825 MARS HILL ROAD
LAND LOTS 269, 208, DISTRICT 2ND SECTION
COUNTY, GEORGIA

PETITION NO: Z-66

ZONING COMMENTS:

Based on the above analysis, Staff recommends **DELETING** to R-20 subject to the following conditions:

SHEET TITLE:
SITE PLAN
OSC (R-30) LANDLIT

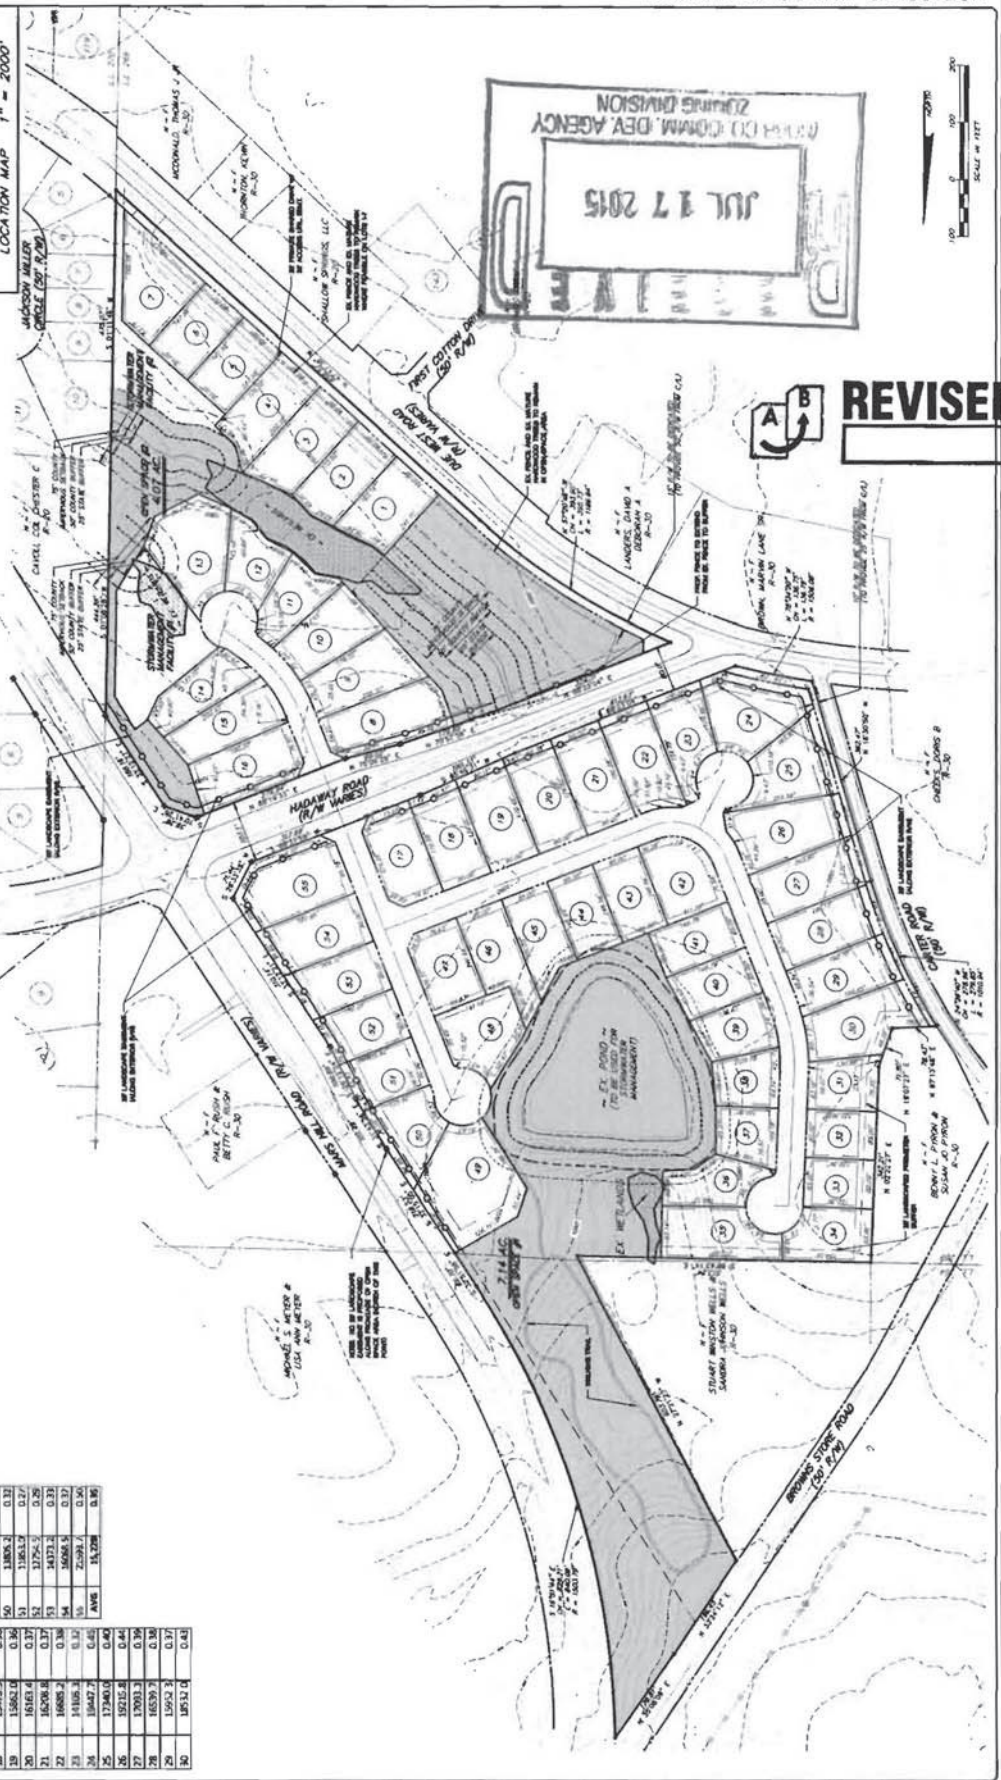
1. Site Plan stamped received on May 7, 2015 does not currently meet the requirements for R-20 Open Space Community, which requires 35% open space. The submitted plan provides 11.21 acres. Required open space for this plan would need to be 12.35 acres.

2. Lots 1 through 4 and a portion of 5 are located within the 25’ state stream buffer and the 50’ county stream buffer. All stream buffers must be within the open space.

3. Open space shall be designed to provide connection to adjacent property when the adjacent property is currently undeveloped or consists of established open space or conservation area. Contiguity of open space is highly desirable. Need to design connection of open space between the tract on the north side of Hadaway Road and the tract on the south side of Hadaway Road.

- Provide comprehensive hydrology/stormwater controls to include development of out parcels.
- Submit all proposed site improvements to Plan Review.
- Any **spring activity** uncovered must be addressed by a qualified geotechnical engineer (PE).
- Structural fill _____ must be placed under the direction of a qualified registered Georgia geotechnical engineer (PE).
- Existing facility.
- Project must comply with the Water Quality requirements of the CWA-NPDES-NPS Permit and County Water Quality Ordinance.
- Water Quality/Quantity contributions of the existing lake/pond on site must be continued as baseline conditions into proposed project.
- Calculate and provide % impervious of project site.
- Revisit design; reduce pavement area to reduce runoff and pollution.

- No Stormwater controls shown _____
- Copy of survey is not current – Additional comments may be forthcoming when current site conditions are exposed.
- No site improvements showing on exhibit.

1. The site is located just west of Mars Hill Road and east of Due West, Carter and Brown Store Roads. The parcel is bisected by Hadaway Road. Approximately 53% of the site drains to the southeast into and through the adjacent West Hill Crossing Subdivision. The remainder of the site drains to the northeast through an existing culvert under Mars Hill Road. The average slopes ranges from 5 to 15% within the active development area (outside the reserved open space).

2. There is an existing farm pond located on the northern portion of the site. This dam will be required to be brought up to current Cobb County design standards.

3. The existing receiving culvert within the West Hill Crossing Subdivision must be evaluated during Plan Review to verify adequate design capacity. The hydrology study must include storage routings through the existing West Hill Crossing detention pond to verify adequate capacity as well.
